SERVICE BULLETIN

No. 629

Piper Aircraft Corporation

Subject: Landing Gear Hose Assembly Inspection
and Replacement.

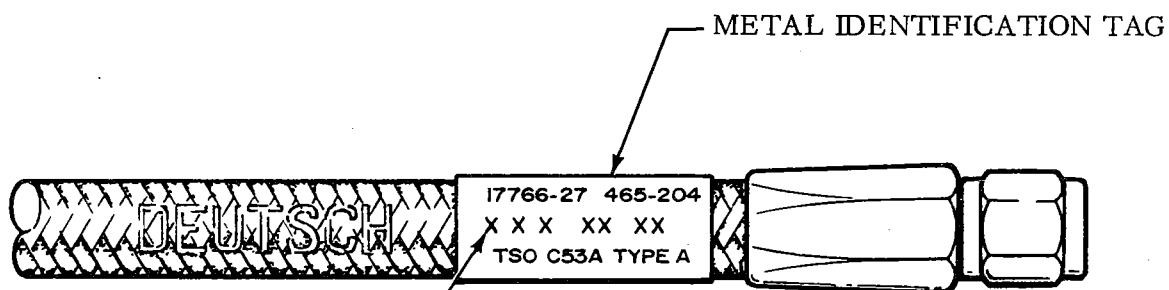
2. Inspect the metal identification tag on the Hose Assemblies for an assembly date of 4Q77 or 1Q78 (See attached sketch).
3. If a Hose Assembly has an assembly date other than 4Q77 or 1Q78, no further action is required. Make an appropriate log book entry of compliance with this Service Bulletin.

INSPECT ASSEMBLY DATE. HOSE ASSEMBLY
WITH ASSEMBLY DATE OF 4Q77 or 1Q78
MUST BE REPLACED.

5. Remove Hose Assembly(ies) which have assembly dates of 4Q77 or 1Q78. Visually inspect the Hose Assembly for blockage, deterioration or signs of leakage which would indicate delamination.

6. If no evidence of delamination is present, replace the Hose Assembly(ies) with new part(s) having an acceptable assembly date and proceed to steps 6.a. and 6.b.

7. If evidence of delamination is present, obtain new part(s) having an acceptable assembly date and proceed with steps 7.a. through 7.f.
